5.1 Pre application feedback and review. Ref 75221/PRC/2022/36

We engaged in a useful and informative pre application process and review with Hillingdon planning and the below is in response to the advice received in the letter on the 20th May.

Pre application visual of the corner of Horton Road

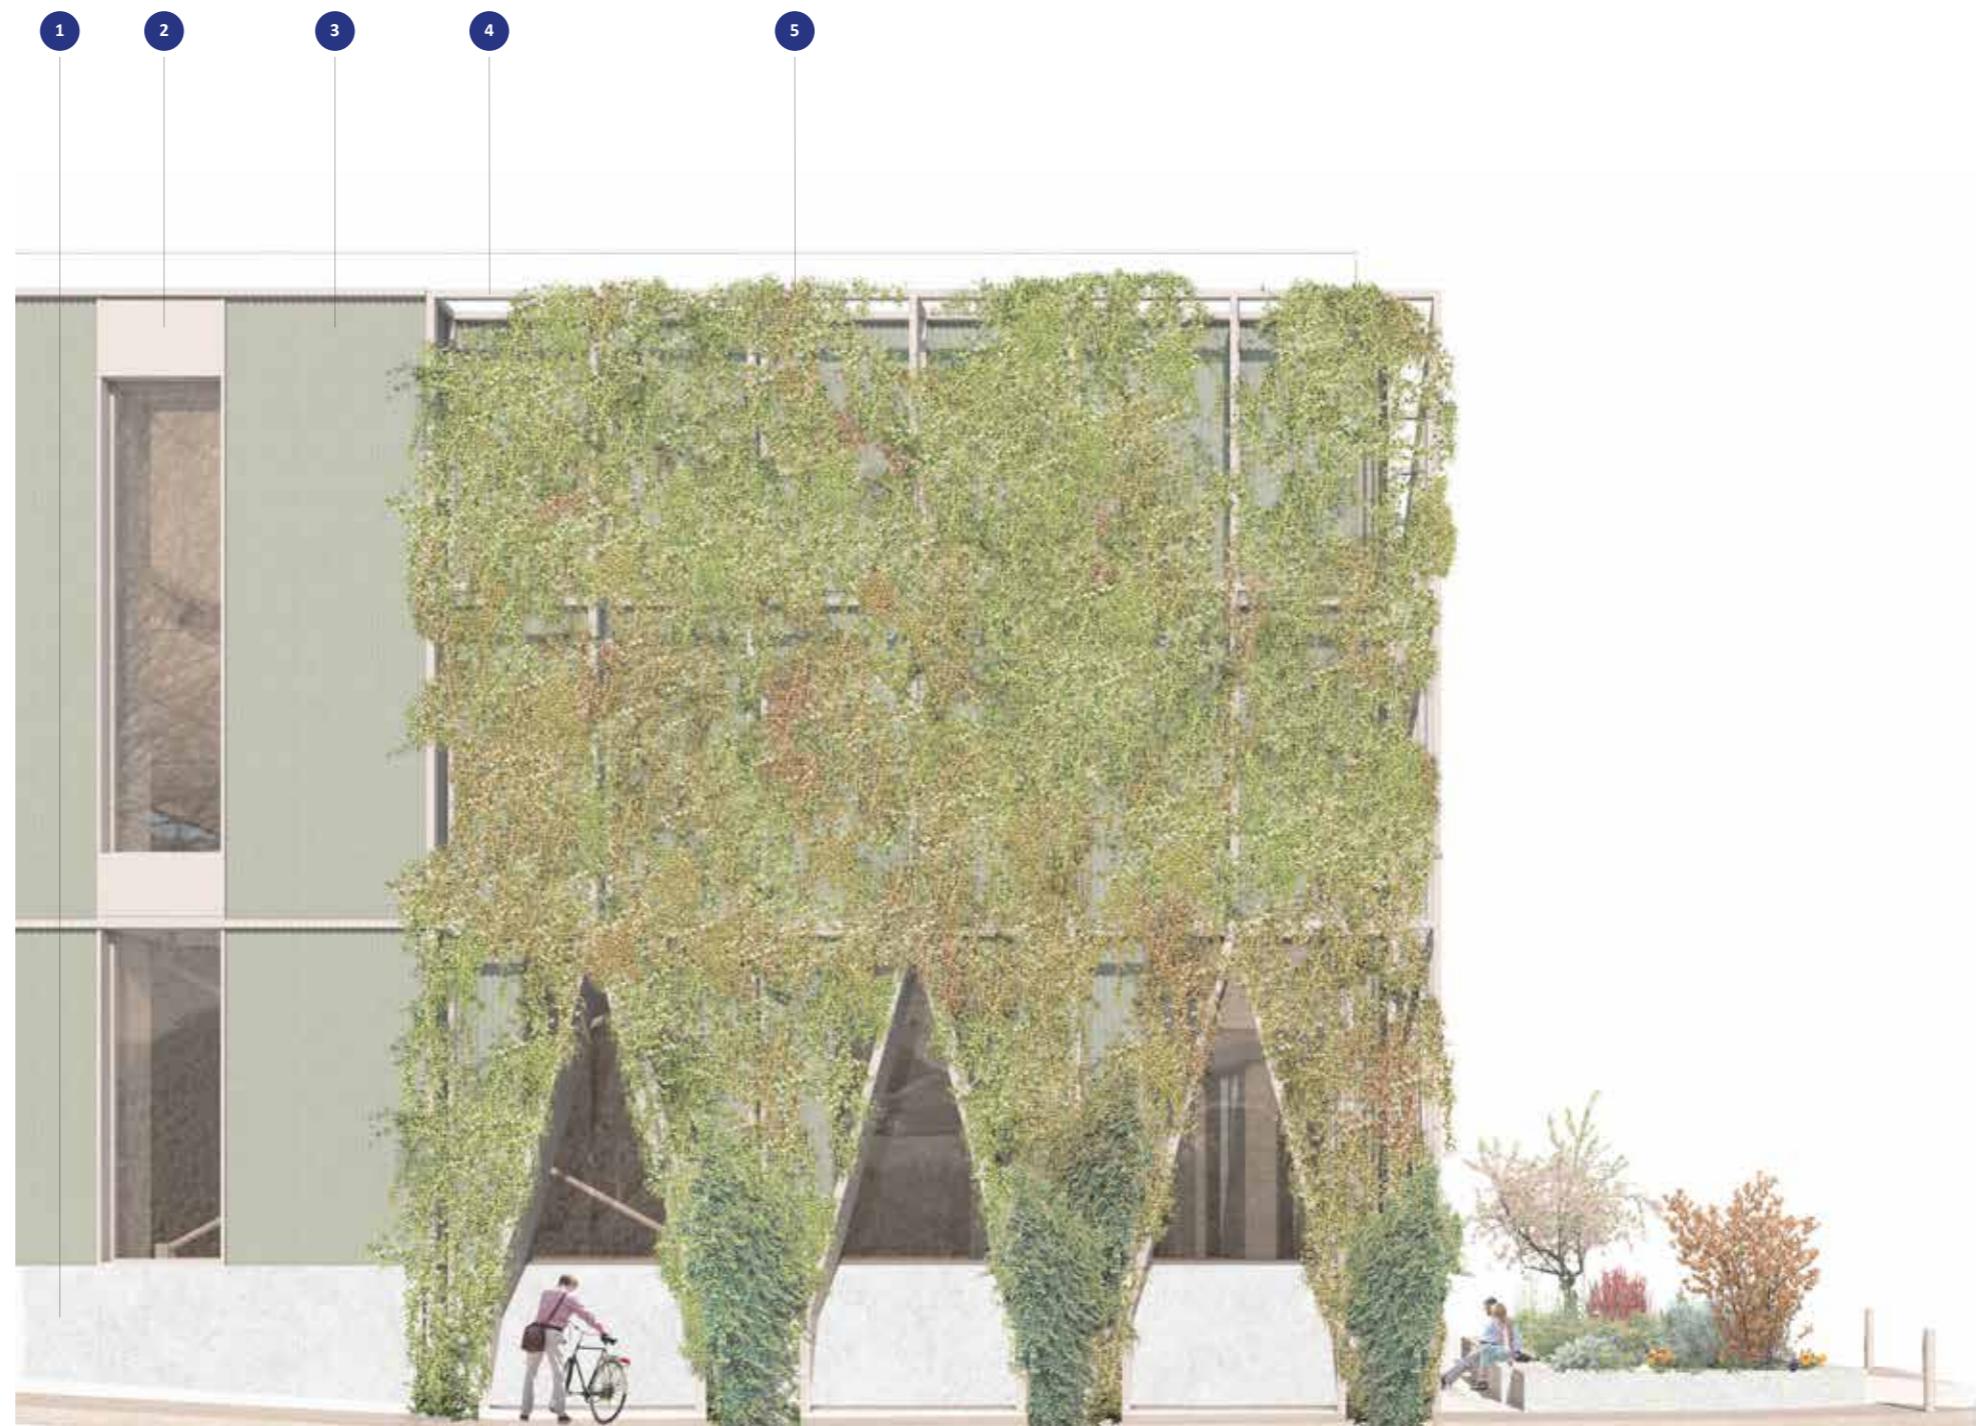
“Some concern is raised in respect of the landscaping around the edge of the proposal, noting that not a great deal of room has been left between the edge of the building envelope and the boundaries of the site, although it was discussed in our meeting that the intention is to maximise opportunities for soft landscaping and biodiversity improvements so that the building blends into the natural landscape to the north and west.”

“Additionally, some concern is raised in respect of the proposed new access from the south, to access the proposed parking area. This proposed access is quite close to both the stopping location for the nearby bus stop and the junction where Horton Road splits, and the design of any new access should take into account these two existing road features to ensure there would be no conflict.”

Following the pre application meeting and feedback we have engaged with a landscape design consultant who has prepared a design for the hard and soft landscaping. Please see the section later in the DAS. To help soften and blend the building into the natural landscape we have added a green wall to the South West/Western elevations. This green wall will be a permanent screen that will grow up a steel frame. This addition will soften the visual impact at the corner of Horton Road and also the view when people walk alongside at ground level. Furthermore the landscaping around the perimeter has been enhanced with flowers and soft landscaping. All of the above will also enhance the bio diversity of the project.

Following the above feedback the access to the car parking has been revised so that the access is to the West and off Horton Road rather than to the South. A car lift is proposed for car access into the basement car parking. Please refer to the attached plans.

6.5 Basement Plan

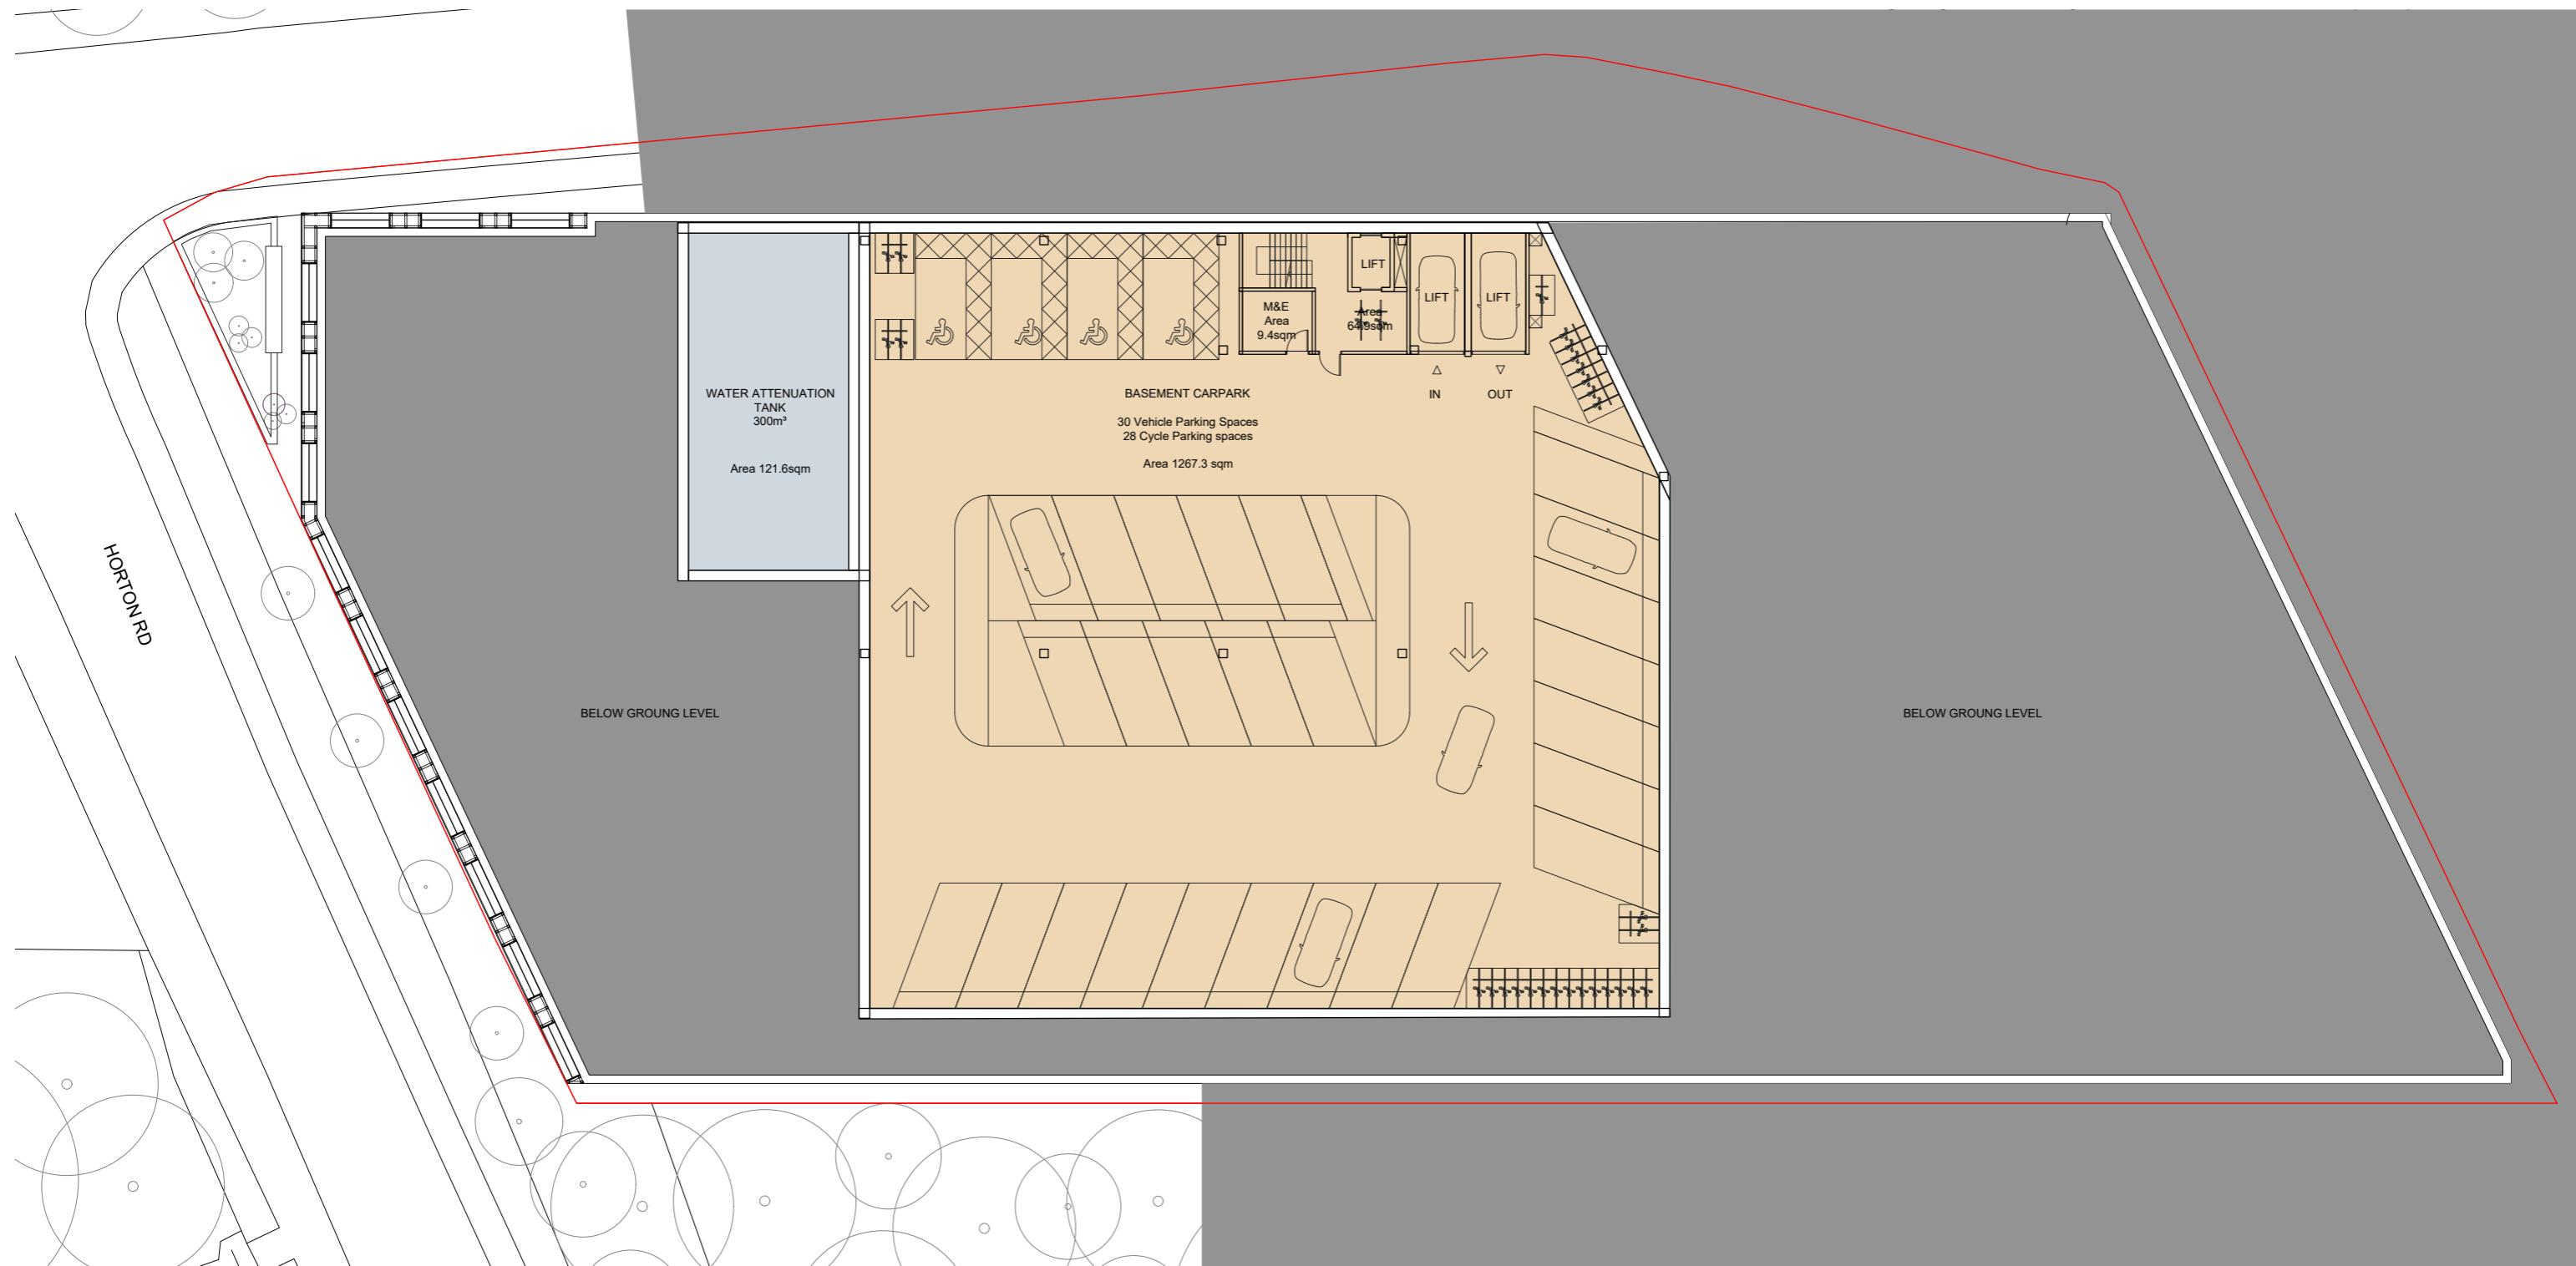
“Developments should provide cycle parking at least in accordance with the minimum standards, ensuring that a minimum of two short-stay and two long-stay cycle parking spaces are provided where the application of the minimum standards would result in a lower provision. Cycle parking should be designed and laid out in accordance with the guidance contained in the London Cycling Design Standards and proposals should demonstrate how cycle parking facilities will cater for larger cycles, including adapted cycles for disabled people.”

The revised proposal deals with cycle provision and the minimum standard is provided in the basement of the building. Please refer to the transport report.
